Addendum No. 01

Project:	Provo DWS - HVAC System Upgrade & Ceiling Replacement	Date:	09 February 2005
Address:	1525 North Freedom Boulevard	Project No.:	0426.01
City, State:	Provo, Utah	Owner No.:	04210920
Owner:	DFCM	Agency:	Department of Workforce Services

**REVISED PARTIAL CEILING PLAN A3/AETH
PROVO WFS PROJECT - ADDENDUM 01**

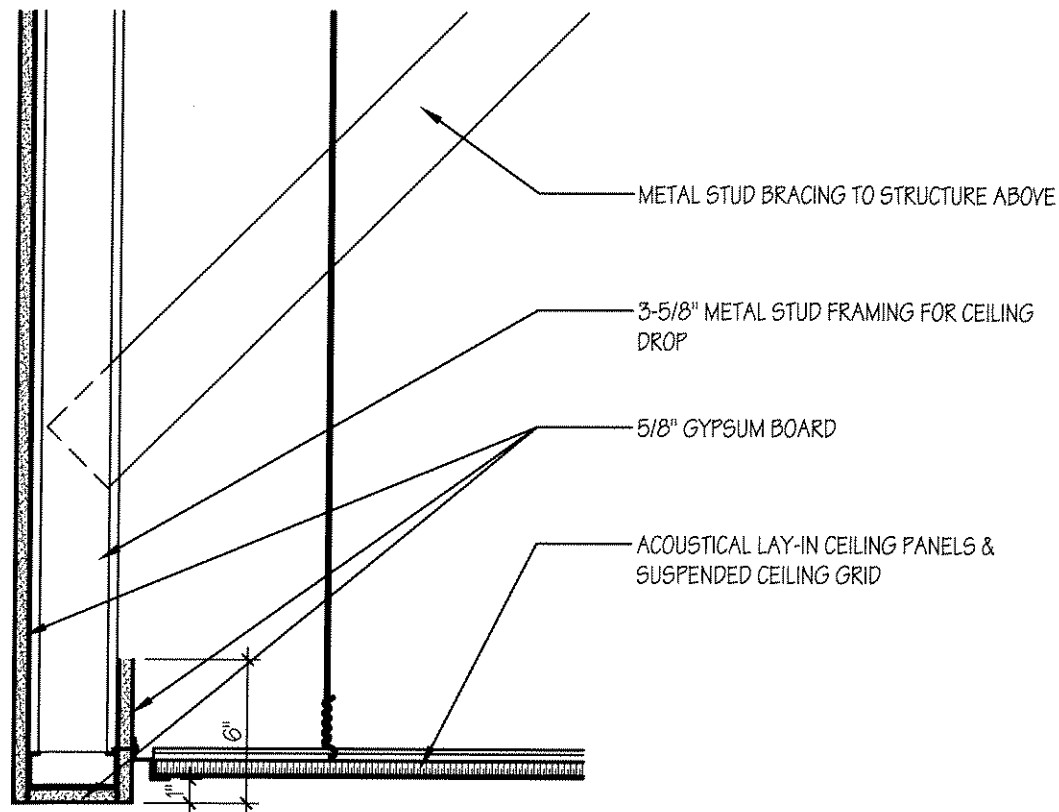
1-19	AE111	Add the attached revised partial reflected ceiling plan: REVISED CEILING PLAN A3/AE111.
1-20	AE501	Add the attached drawing: DETAIL B4/AE501.
1-21	AE601	Add the attached drawings: REVISED DETAIL A3/AE601, REVISED DETAIL C4/AE601, REVISED DETAIL C5/AE601.
1-22	AE601	DOOR SCHEDULE: Revise the "DOOR TYPE for DOOR 019 to read B."
1-23	AE601	DOOR SCHEDULE: Revise the "DOOR FINISH for ALL DOORS to read STAINED."
1-24	MH200	Add the following General Note: "1. Fire sprinkler branch piping shall be re-routed or re-positioned as necessary to accommodate the reconfigured floor plans and the proximity of new and/or relocated walls. In addition, the branch piping shall be re-routed or re-positioned as necessary to avoid the ceiling grid t-bar and conflicts with light fixtures and/or mechanical grilles. Any new branch piping shall be schedule 40 black steel. Should new heads be needed, pendant type heads similar to the existing heads shall be used. Replace missing fire sprinkler escutcheons as necessary. Allowance shall be made for escutcheons documented as missing or damaged before the start of construction. Escutcheons requiring replacement due to loss or damage during construction shall be replaced at the expense of the contractor."

ESD-4

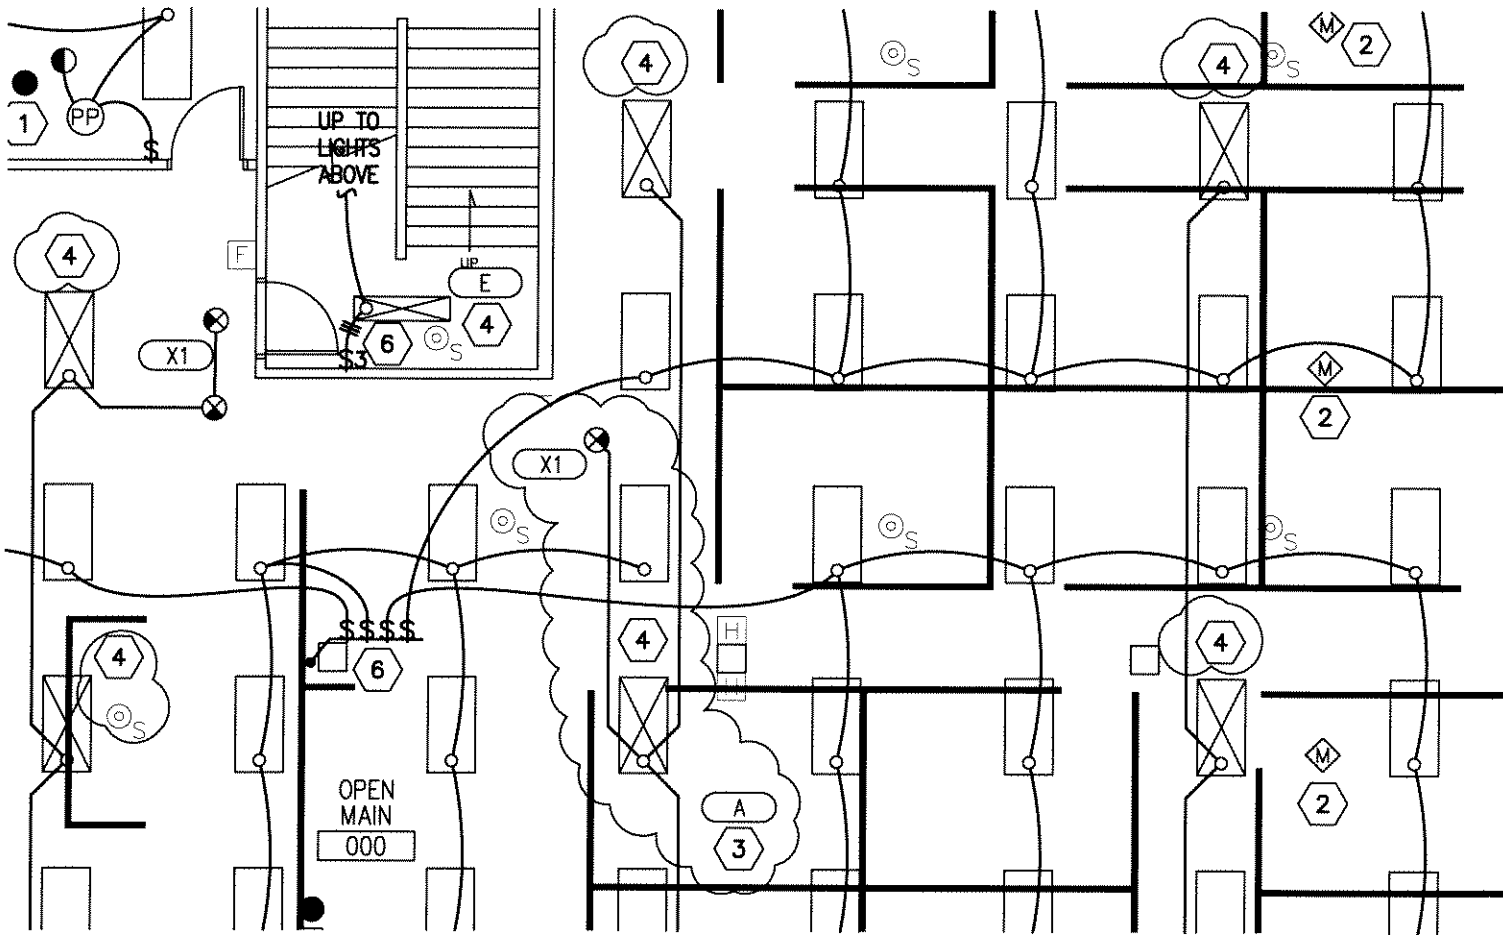
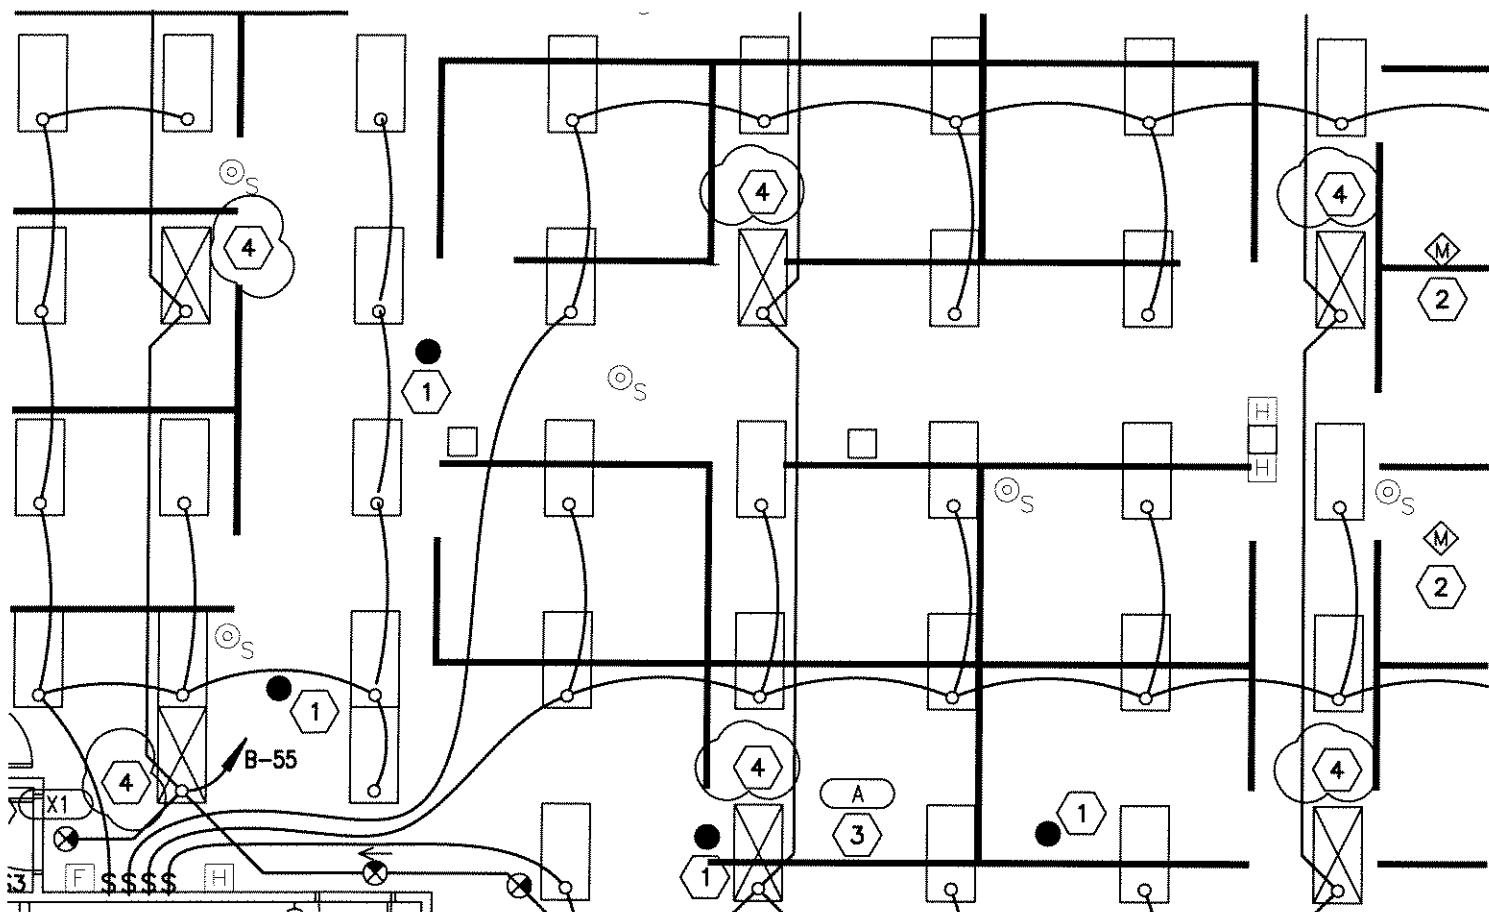
1-29	ED101	Revise sheet keynotes (see attached drawing ESD-2).
1-30	ED102	Revise sheet keynotes (see attached drawing ESD-3).
1-31	EE100	Provide sheet keynotes callout no. 4 for egress lighting (see attached drawing ESD-4).
1-32	EE100	Provide sheet keynotes callout no. 4 for egress lighting (see attached drawing ESD-5).
1-33	EE100	Provide power connections to occupancy sensor power packs (see attached drawing ESD-6).
1-34	EE101	Provide power connection to occupancy sensor power pack (see attached drawing ESD-7).

ESD-10

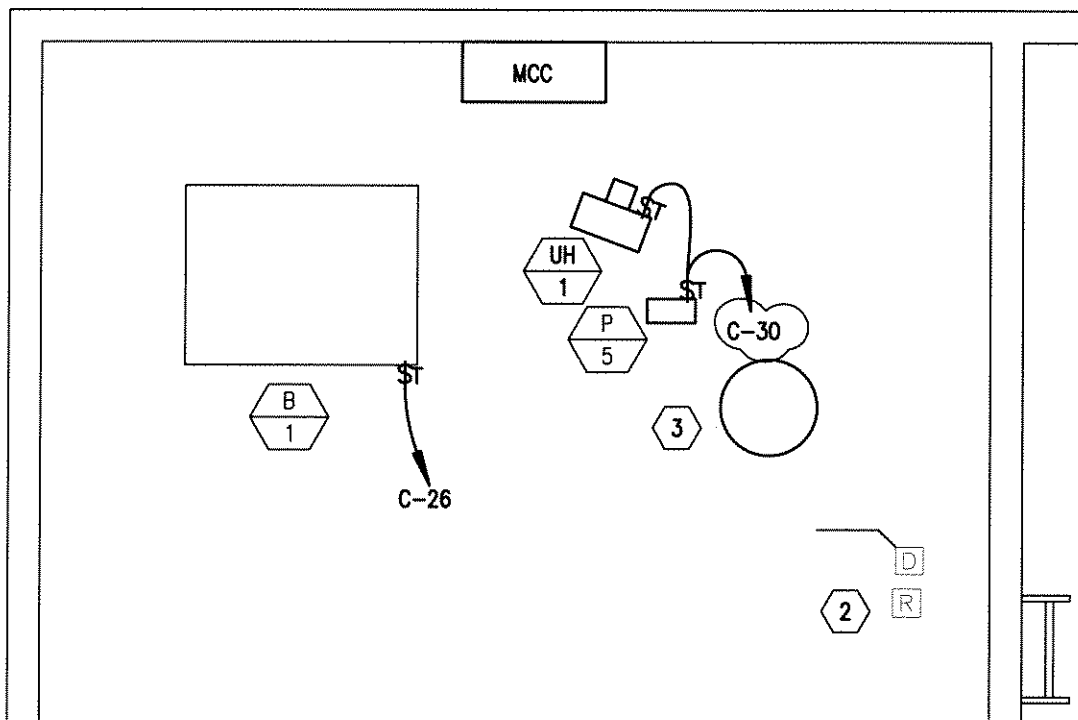
Item No.	Section or Sheet No.	Description
1-35	EE101	Provide circuit to lights and exit signs (see attached drawing ESD-8).
1-36	EE101	Provide circuiting information for Chiller CH-1 and AC Unit AC-10 (see attached drawing ESD-9).
1-37	EE101	Provide circuit to lights (see attached drawing ESD-10).
1-38	EE102	Provide circuiting to Pump P-5 and Unit Heater UH-1 (see attached drawing ESD-11).
1-39	EX501	Revise sheet keynotes (see attached drawing ESD-12).
